**DOCKET NO: A-98-49
II-B1-16**

**TECHNICAL SUPPORT DOCUMENT FOR SECTION 194.23
REVIEW OF THE 2004 COMPLIANCE RECERTIFICATION
PERFORMANCE ASSESSMENT BASELINE CALCULATION**

**U. S. ENVIRONMENTAL PROTECTION AGENCY
Office of Radiation and Indoor Air
Center for the Waste Isolation Pilot Plant
1310 L St., NW
Washington, DC 20005**

March 2006

Figure 6-1. Initially Anaerobic, Amended Humid Experiments
(Gillow and Francis 2003)

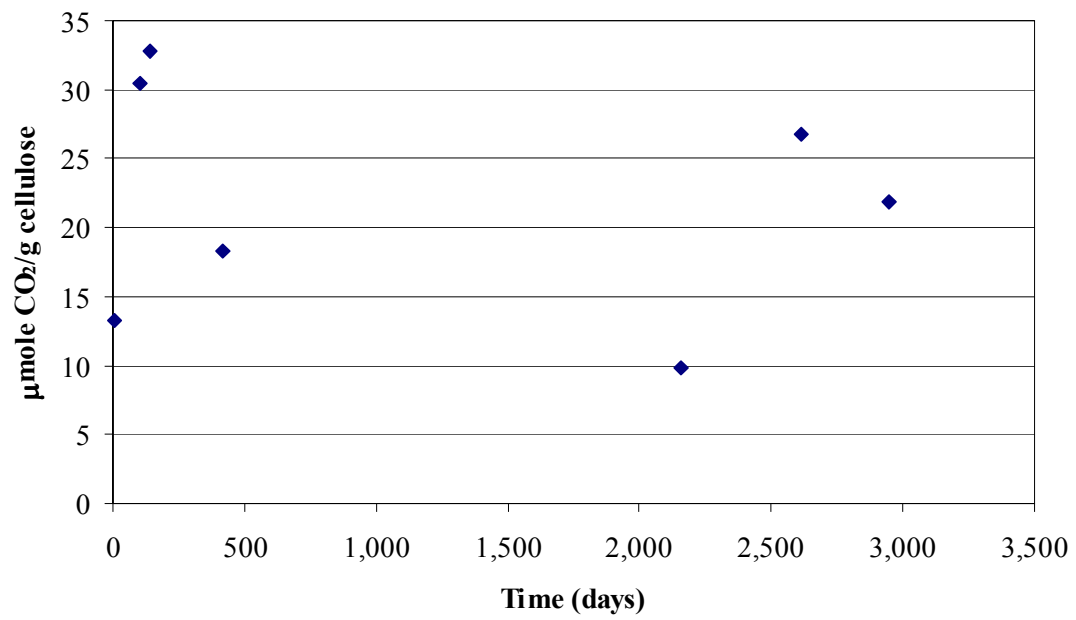
Nemer et al. 2005 used data from the unamended experiments to determine the maximum long-term gas generation rate under humid conditions. The reasons for excluding data from the humid amended experiments were not stated. However, examination of the data reported by Gillow and Francis 2003 shows that the long-term rate for the humid amended experiments was essentially zero (Figure 6-1), and the lower limit for the humid gas generation rate was assumed to be zero by Nemer et al. 2005. The Agency successfully reproduced the calculation of the maximum long-term humid gas generation rate using the same carbon dioxide data as Nemer et al. 2005 (Appendix C). The assumption that the humid gas generation rate would range between this maximum rate and zero as observed in the amended humid experiments is consistent with the available experimental data.

Figure 7-1. Felmy et al. 1991 ThO₂(am) Solubility Data Difference Value Histogram
 (Source: ASTP.2005.04A_Xiong et al, An Sol Unc, Rev 1, Spreads, 2 of 2.xls)
 This distribution was used to develop the +IV actinide solubility uncertainty for the PABC.

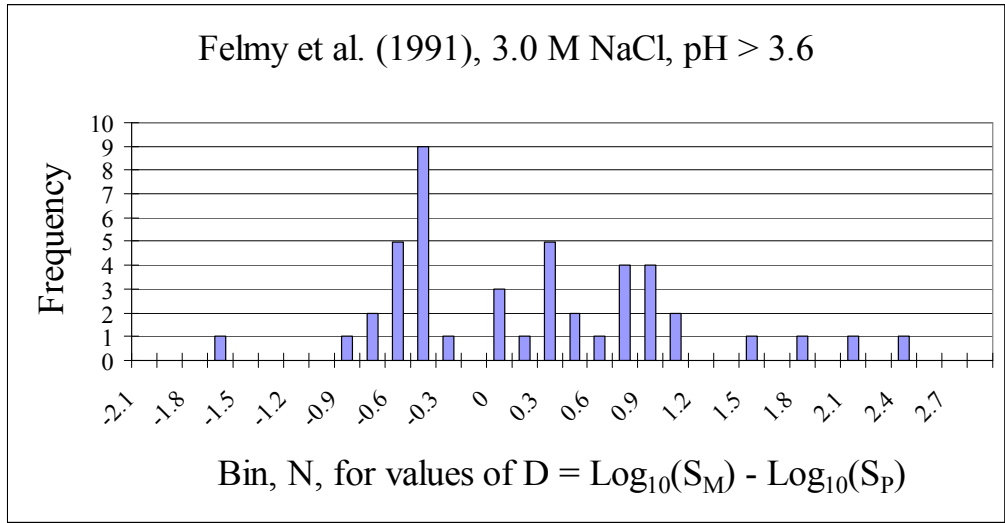
For example, the distribution of D values for the Felmy et al. 1991 ThO₂(am) data is illustrated in Figure 7-1. Even though the thermodynamic data for ThO₂(am) in FMT_050405.CHEMDAT were derived from this study, the range of difference values was relatively large, with D values that ranged from -1.75 to 2.39. The distribution is weighted somewhat toward positive D values, indicating that the model tended to more often underpredict measured solubilities. This example indicates that using data included in the development of the thermodynamic database may not result in a solubility uncertainty distribution that is closely grouped or symmetric around D values of zero. Therefore, in future determinations of actinide solubility uncertainty distributions, it would be advisable to include all available data, even if it was used to develop

Figure 8-5. The CRA-Revised (PABC) Full Mining Zones Overlaid with the 1996 CCA (red) and CRA delineations (blue)
 (Source: Lowry and Kanney 2005)

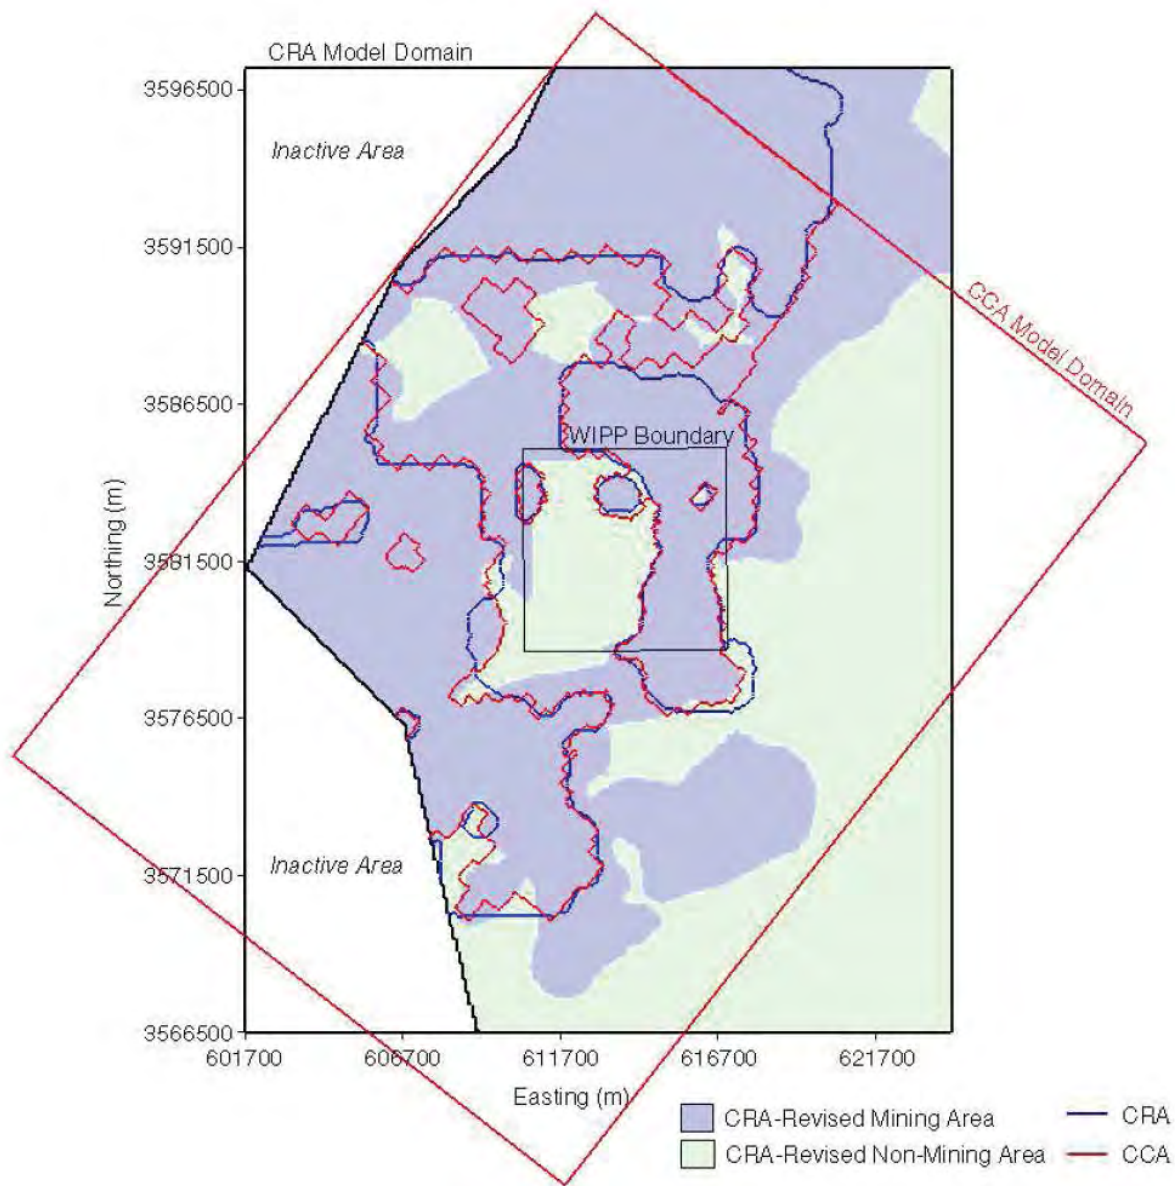
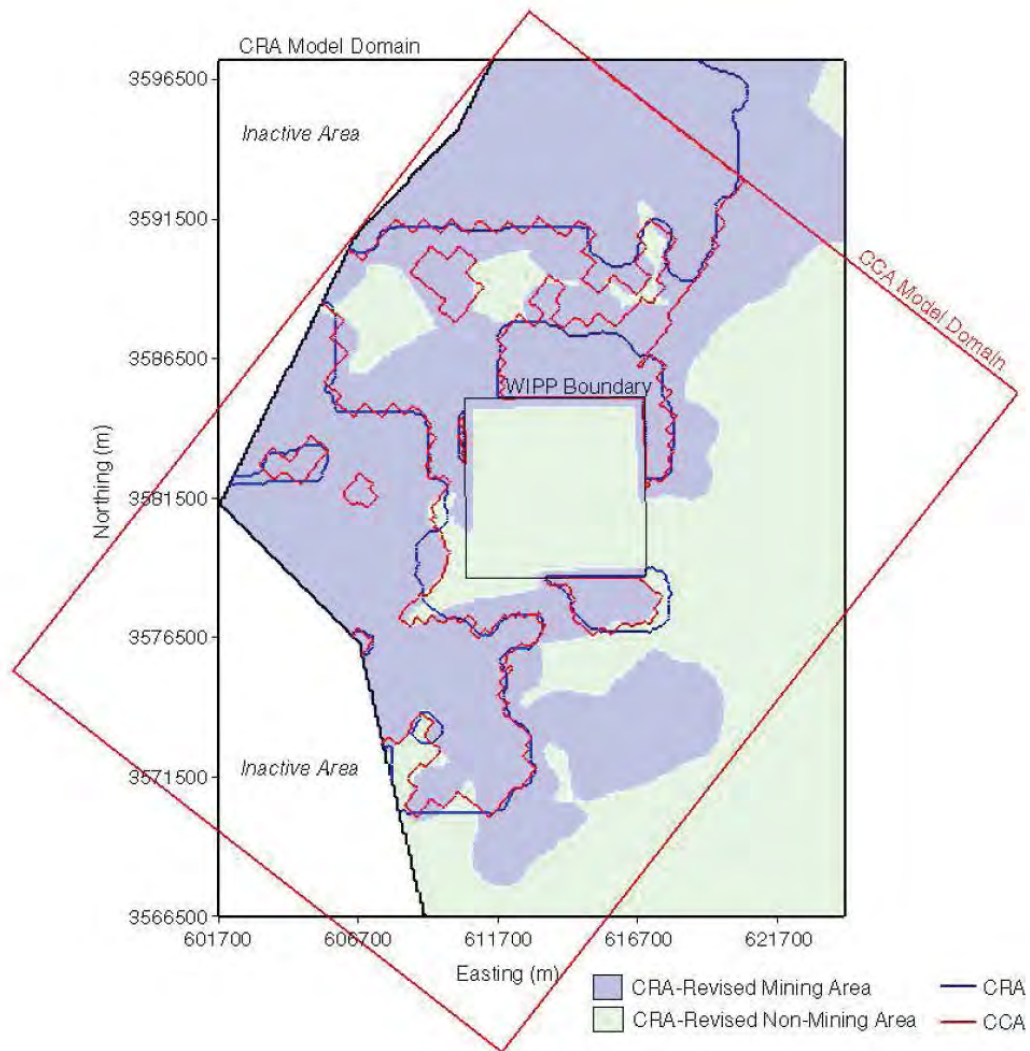
The model domains of the CCA grid, CRA grid, and the CRA-revised (i.e., PABC) grid for both the full- and partial-mining scenarios are shown in Figures 8-5 and 8-6, respectively. Results show that for both the full- and partial-mining scenarios, the median particle travel times of 75,774 and 129,202 years are 4.14 and 7.06 times longer than for the non-mining scenario (18,289 years). The increase in transmissivity due to mining increases the relative flow rate through the mining zones, with a corresponding decrease in flow through the non-mining zones. This decrease in flow through the non-mining zones produces longer travel times for the mining scenarios. Comparing the full-mining scenarios of the PABC analysis to the CCA and CRA calculations, the median travel times are approximately 2.53 and 1.14 times longer, respectively. For the partial mining case, the median travel time for the PABC is 9.33 times greater than the median for the CCA, and 2.67 times greater than the CRA. DOE attributes this increase in the travel time over the CRA to the higher percentage of area deemed as mining zone. DOE points out that unlike the CRA, a negative correlation was found in the PABC analysis between the travel times and the random mining factor (the higher the random mining factor, the longer the particle travel time). DOE believes this is also due to a higher percentage of mining zone area in the PABC analysis as compared to the CRA. With a higher percentage of mining area, the random mining factor has a larger influence on the regional flow regime. As the mining factor is increased, the flow through the non-mining areas is decreased, producing longer travel times and the negative correlation. However, additional analysis shows that most of the travel time variability is due to differences in the base T fields and not the random mining factor.

By eliminating the exclusion zone around the existing oil and gas wells the DOE has addressed the Agency's concern with respect to the mining scenario.

Figure 11-3. Combined Total Mean Normalized Release CCDFs for All PAVT and PABC Replicates
 (Source: Vugrin 2005h, Figure 1)

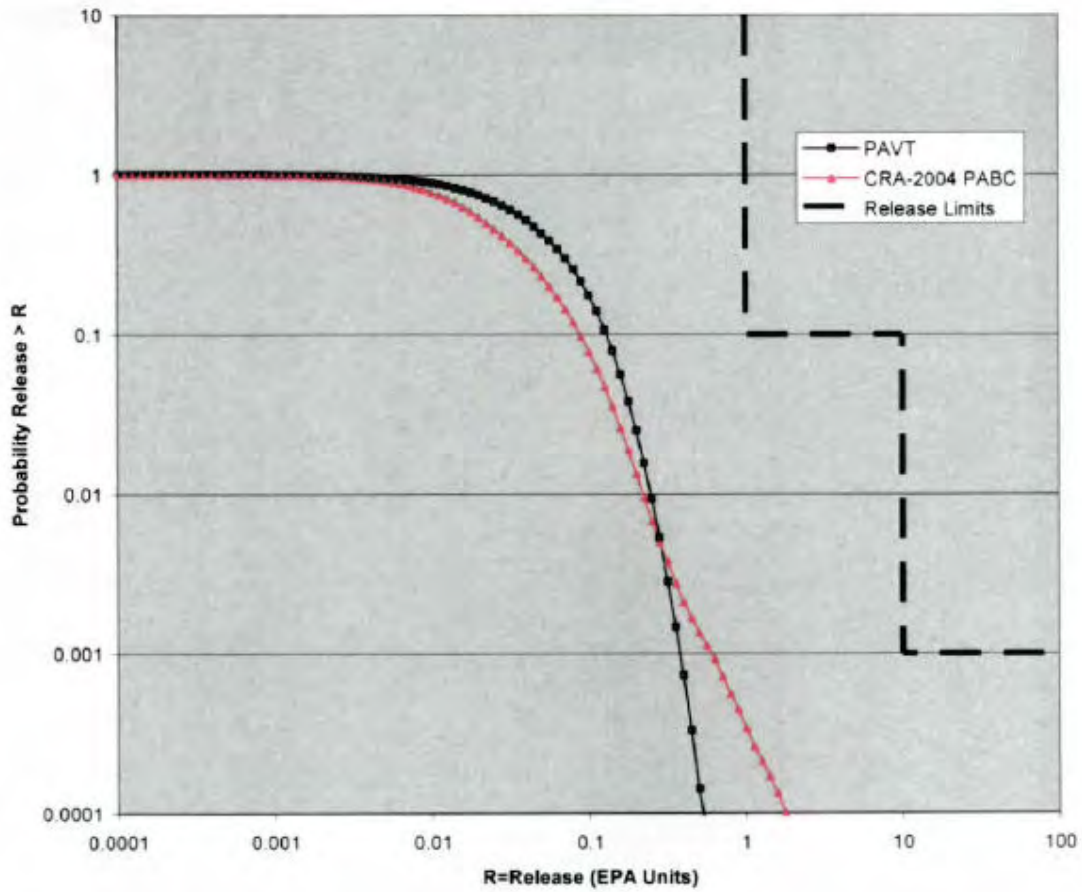
The increased releases at low probabilities in the PABC illustrated in Figure 11-3 reflect the increased DBRs and, as described in Section 10.2.2, are primarily due to higher brine saturations resulting from lower microbial gas generation rates, and to changes in the PABC that increased actinide solubilities. As can be seen from Table 11.1, for the PABC both the calculated mean releases and the upper 95% confidence levels on the mean have remained less than the regulatory limits at both 0.1 and 0.001 probabilities. Therefore, the Agency concludes that the WIPP continues to comply with the containment requirements of 40 CFR 191.13.
